Comments on Preliminary Hydrogeological Report & Large-Diameter Well Development and Testing Plan for Well #3

Steven Winkley, P.G.

Figure 1. Well 2 Log

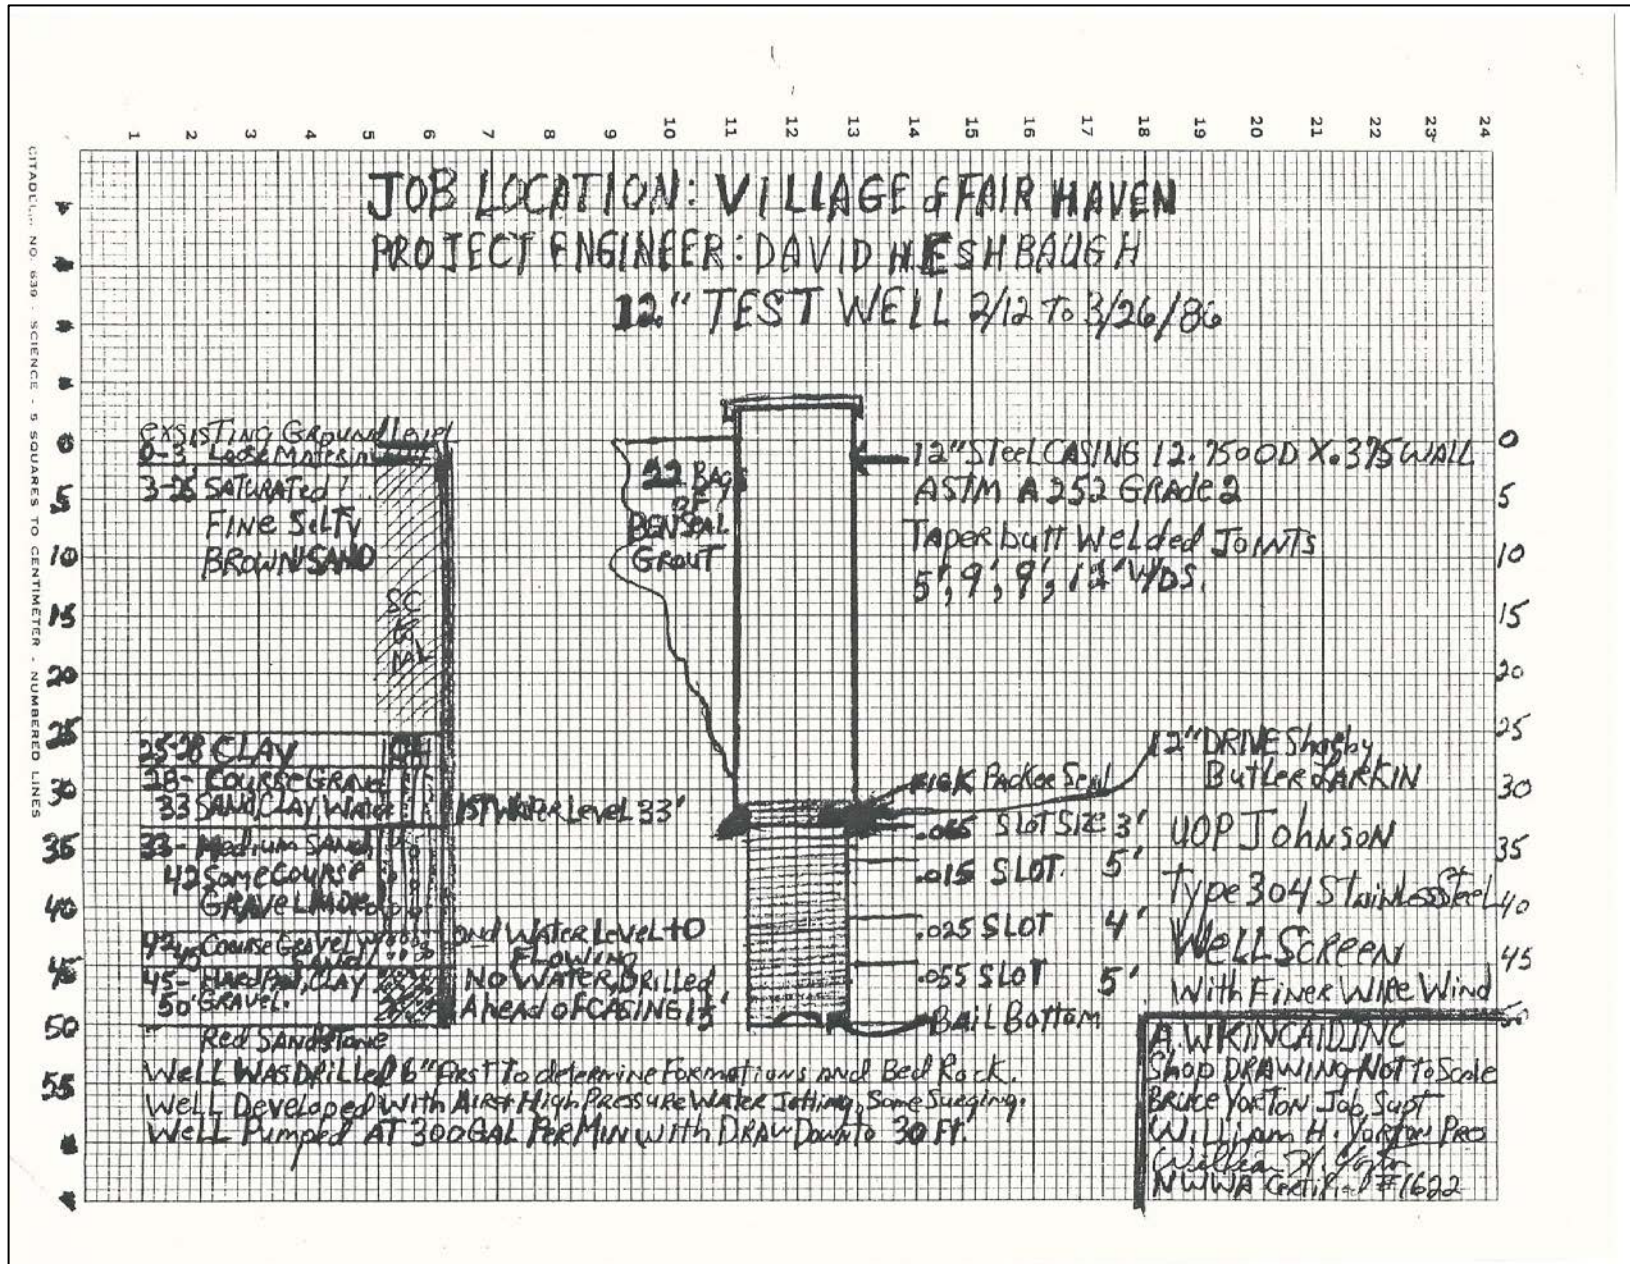
In its description of the existing wells and wellfield, HydroSource indicates on page 5 of its report and testing plan that *"less information exists for Well #2,and the well is reported to be 54 feet deep. The top of the screen assembly is at 35.5 feet, but the screen length and slot size are not known."* Figure 1 below is the well log and completion report for Well #2. This well is 50 feet deep and is screened from 33 to 50 feet deep. However, hardpan (till) was encountered at 45 feet and bedrock at 50 feet. Upon completion, the well reportedly produced 300 gallons per minute with 30 feet of drawdown. A correction should be made to the report.

Figure 2. Local Aquifer Mapping

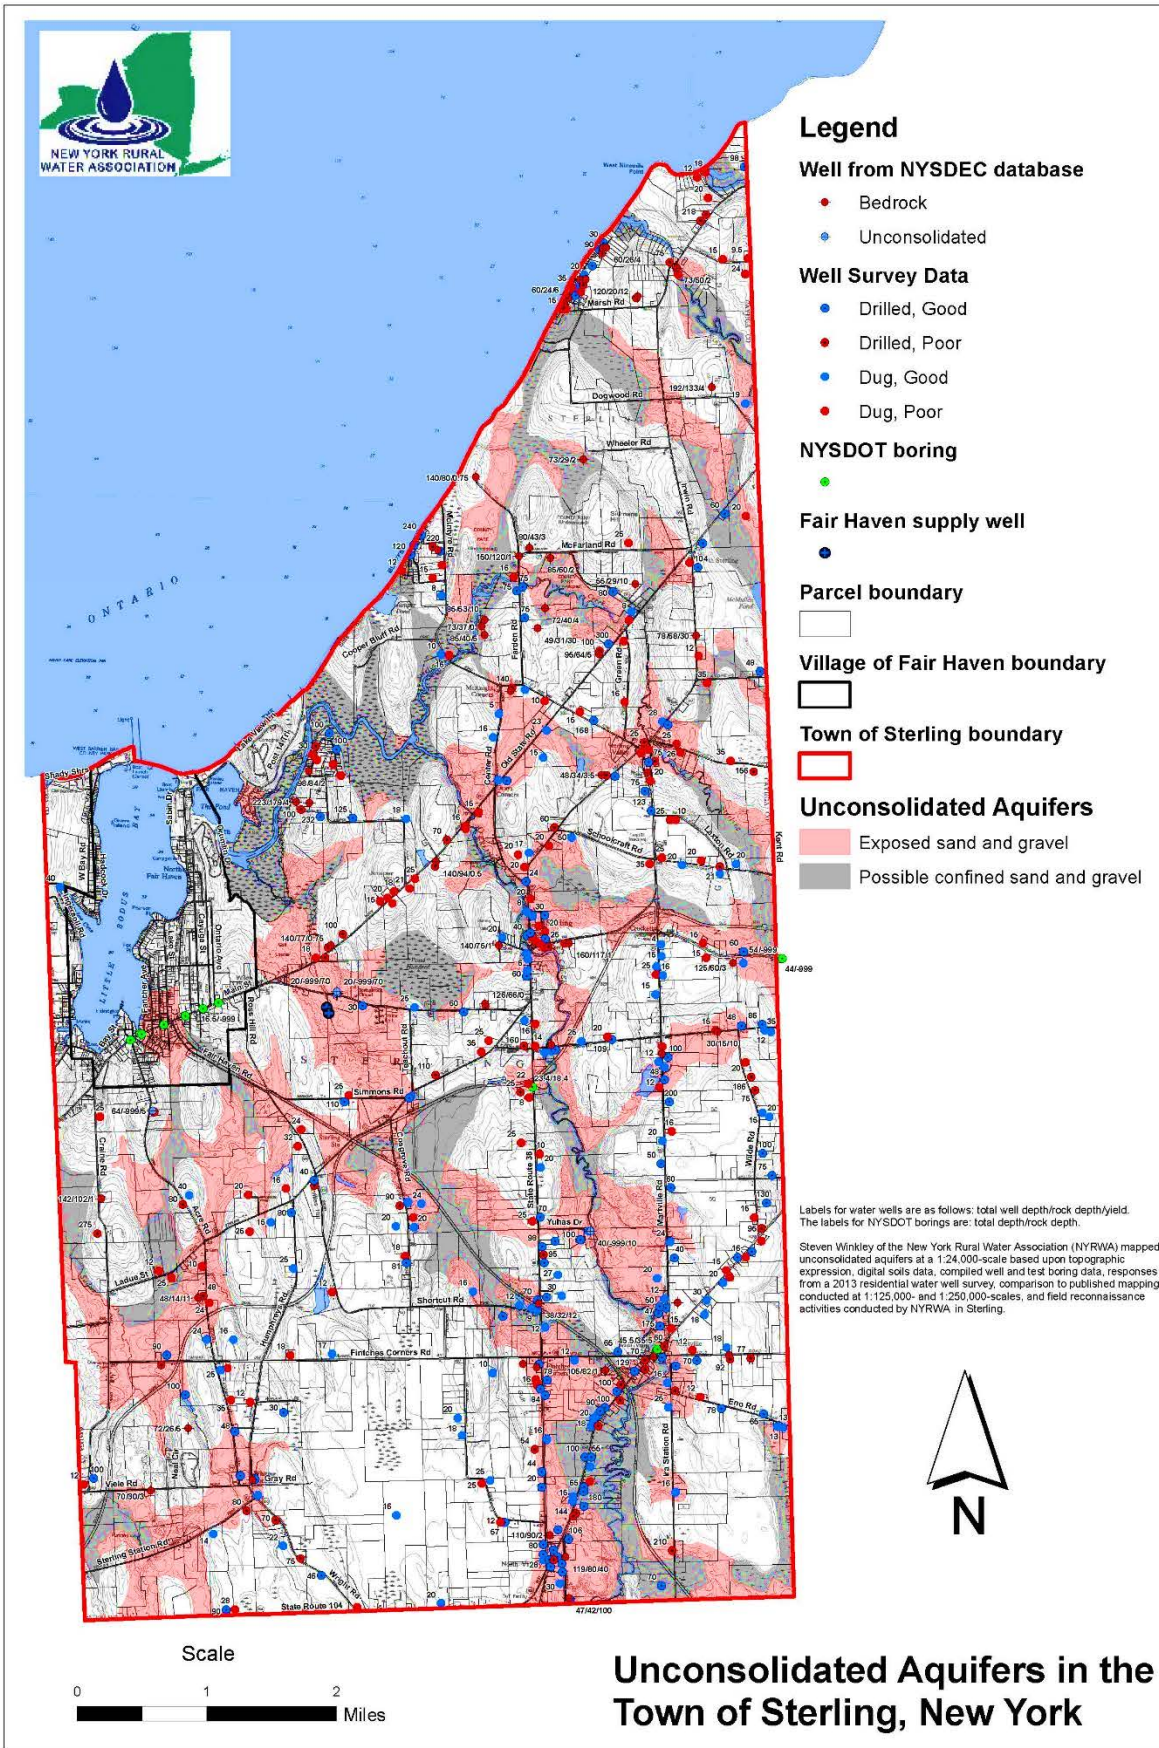
Given my mapping of the local aquifers in this area (Figure 2) based upon compiled well data, the local surficial geology, and the bedrock topography, I think extension of the watershed southward to that shown in Figure 15 of HydroSource's report and testing plan is not justified. In relatively shallow glacial aquifers such as in the Fair Haven/Sterling area, surface topography is generally a good predictor of the groundwater (water table) topography. However, it is conceivable that the groundwater divide separating northwestward flow towards the supply wells may not coincide precisely with the topographic divide situated near Simmons Road. I agree with HydroSource that *"it is reasonable to expect that the wellfield may capture groundwater from an area larger than the confines of the topographically defined watershed."*

Realistically, the groundwater divide may extend some unknown distance southward to perhaps the area of Sterling Station and/or Cosgrove Roads. However, the much more extensive regional contribution area drawn by HydroSource is simply not supported by available surficial geology and water well data. More information on the aquifer's depth, areal extent, geometry, and hydrology are necessary to support the expanded watershed delineated by HydroSource on Figure 15 of their report and testing plan.

Figure 3

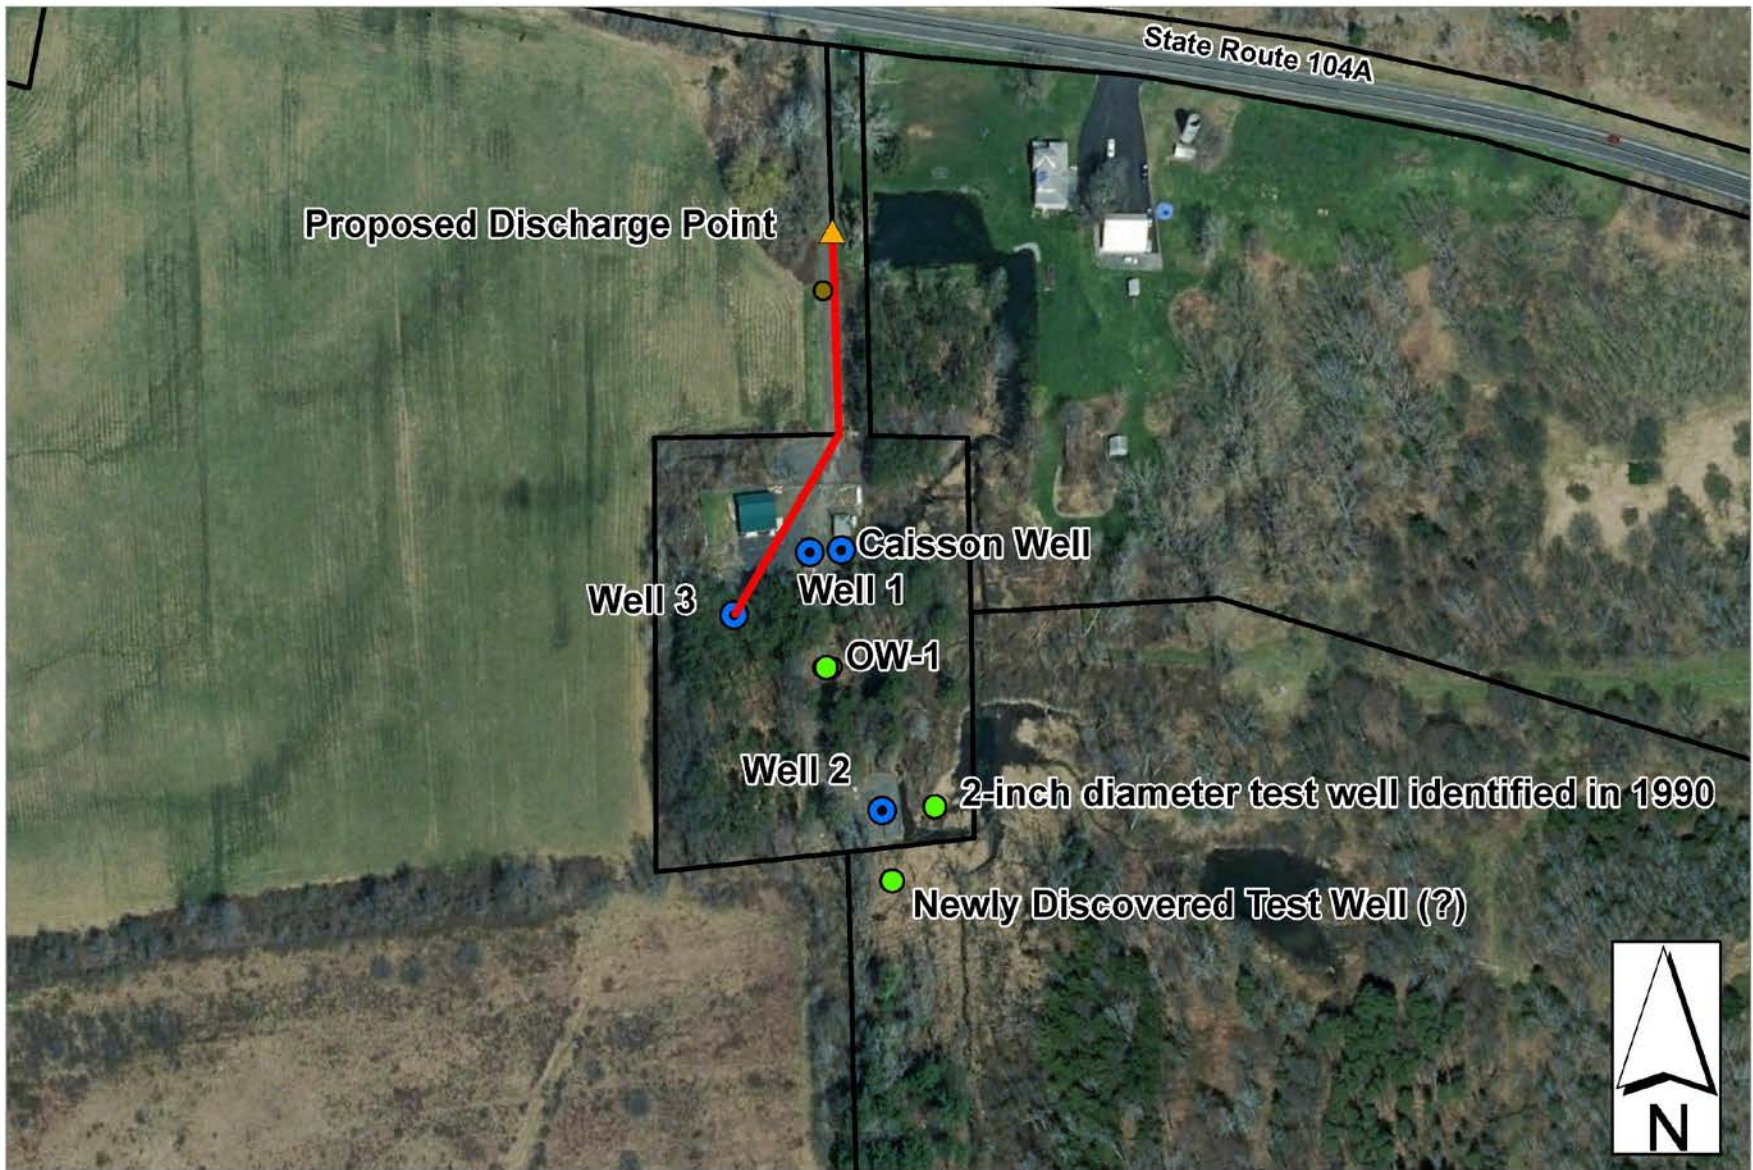
The recently found test well south of Well #2 (very approximately located on Figure 3) must be surveyed and vertically sounded to determine its suitability for monitoring. In addition, a second small diameter well some 50 feet east of Well #2 has been referred to in several reports (see Figure 3). This should be searched for as well.

According to the pumping test plan, water pumped during the test is to be discharged near the stream approximately 230 feet northeast of Well #1. The NYSDEC pumping test protocols indicate that the discharge water should be conducted at least 300 feet down gradient unless it can be demonstrated that discharged water will not recharge the aquifer being tested. Since the thickness and texture of the overlying lacustrine sediments has been observed to vary across the wellfield site, I believe the discharge water from the test should be conducted approximately 400 feet north directly into the stream where it exits the wellfield property and starts flowing northward towards Route 104A (see Figure 3). This location also reduces the threat of flooding to the immediate wellfield area since the stream is much narrower and closer to the water system infrastructure at the discharge point proposed by HydroSource.
